Technical Service Bulletin: TSB260095

Oil Consumption - CES 20092

- X15N CM2380 X150B

Figure 1, Oil Specifications

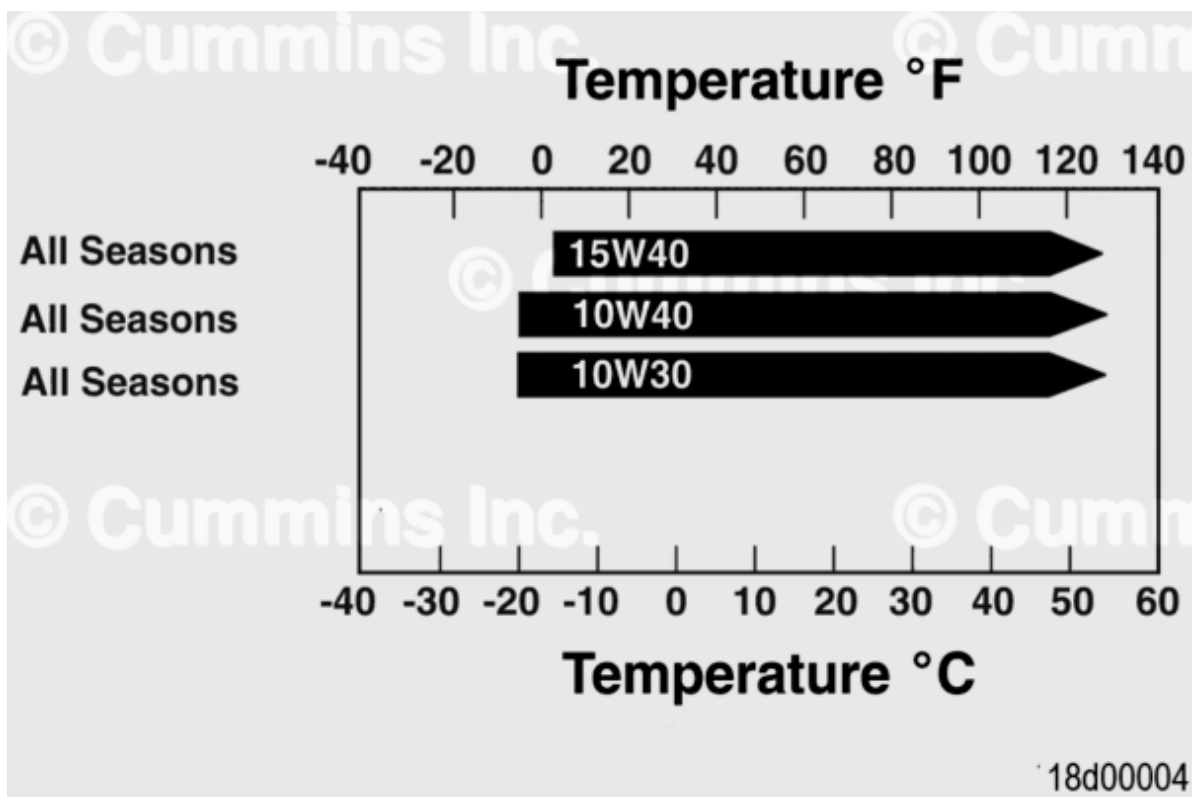
To reduce lubricating oil consumption, utilize a higher viscosity lubricating oil hot number, while maintaining a suitable cold number for conditions. This will require deviating from the guidelines of (1231-018-003) Lubricating Oil Recommendations and Specifications in (6383175) X15N CM2380 X150B Operation and Maintenance Manual, bulletin 6383175.

- -17 °C [0 °F] and above ambient temps utilize a 15w40.
- -40 °C [-40 °F] to -6 °C [20 °F] ambient temps utilize a 10w40.

There are no 5w30 or 0w30 oil certified to CES20092 and 10w30 at higher ambient temperatures leads to increased lubricating oil consumption.
